# Access Compliance Report

## Public Rights-of-Way

### (Pedestrian Signals)

Intersection ID: N/A	Main Street:	Cross Street: N/A	Location: N/A
ADA ID: 44749741981B	Signal Type: One Push Button-Non APS	Overall Compliance: No	Severity Score: BTN 1: N/A BTN 2: N/A No BTN: N/A
Codes/Mitigation Info/Possible Solution		Field Measurements/Component Compliance

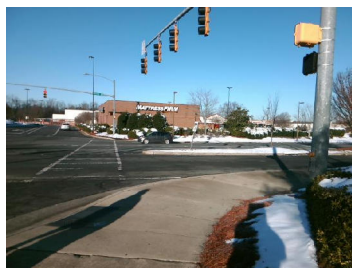
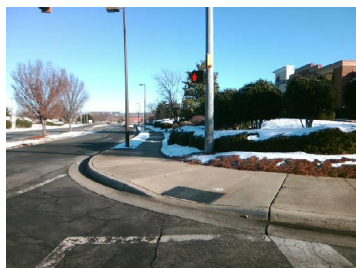
PROW/ADA: TMUTCD 4e.08, R404.2, R404.3, R404.7.3, R404.7.2

N/A	B 1 Clear Xing Direction?	Yes	N/A	B 2 Clear Xing Direction?	N/A
	B 1 Crossing Direction	To W		B 2 Crossing Direction	N/A
No	B 1 DistanceTo XWalk (in)	168.0	N/A	B 2 DistanceTo XWalk (in)	N/A
No	B 1 DistanceTo Curb (in)	152.0	N/A	B 2 DistanceTo Curb (in)	N/A
Yes	B 1 Diameter (in)	2.0	N/A	B 2 Diameter (in)	N/A

Possible Solutions: Replace Signal Push Button With APS Button on New Post. Remove & Relocate Sign.
